Product Change Notification

Product Line:	5 pole A Series	Part No:	NC5F/MA*
Piece Part:		Part No:	
Engineering Change Request:		Date:	
Engineering Change Execution:		Date:	July 2012
Comments:	New connector design

Affected products:	<p>Changed versions: NC5FAH, NC5FAH-D, NC5FAH-0 NC5FAV, NC5FAV-D NC5MAH, NC5MAV</p> <p>Remaining versions: NC5FAV-SW, NC5FAV-SW-D, NC5MAV-SW</p>
--------------------	--

NC5MAV

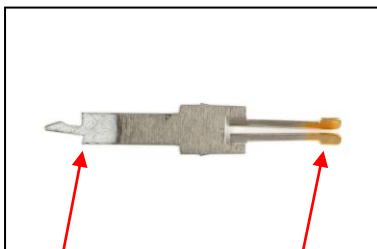
- **New housing design:**

Plastic housing optimized for best workability. Plastic material remain polyamide PA6.6 30%GR with flammability rating UL94HB.

NEW Plating

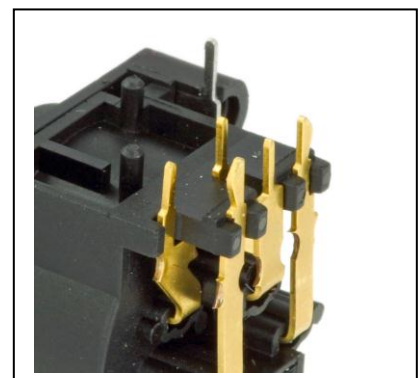
- **New female contact design:**

Contact design remain fork type. Plating adapted by selective gold plating of contact area and tin plated pcb termination area for best conductivity and solderability. Tear drop design and pcb footprint remains unchanged

Female

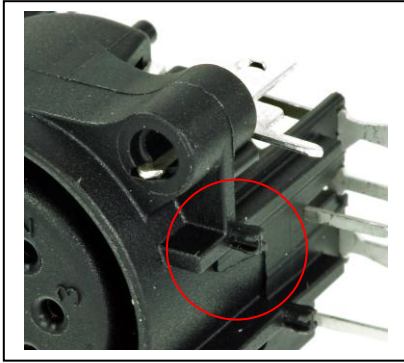
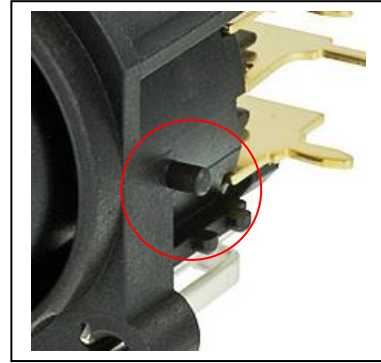
- **New location pin:**

The cylindrical pin shape is replaced by the press-fit design like on the A- and B-series. The pcb layout is not changed and remain the same. Existing pcb's can be further used.

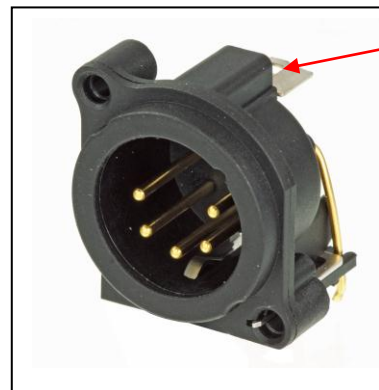
- **Male locking element:**

Locking element incorporated into the plastic housing instead of metal piece. Locking force greater than 200N.

NC5FAV

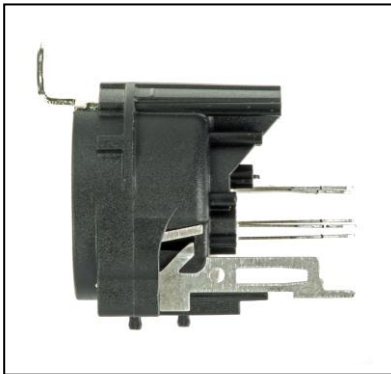
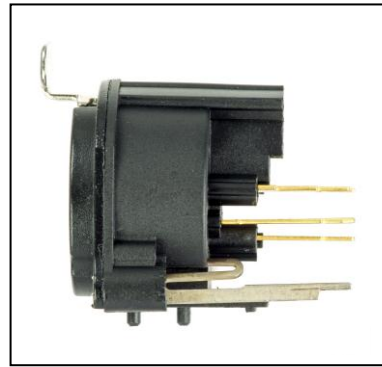
- **New female ground contact design:**

Ground contact design similar to the shape of ground #2 of A, B and A-combo series.
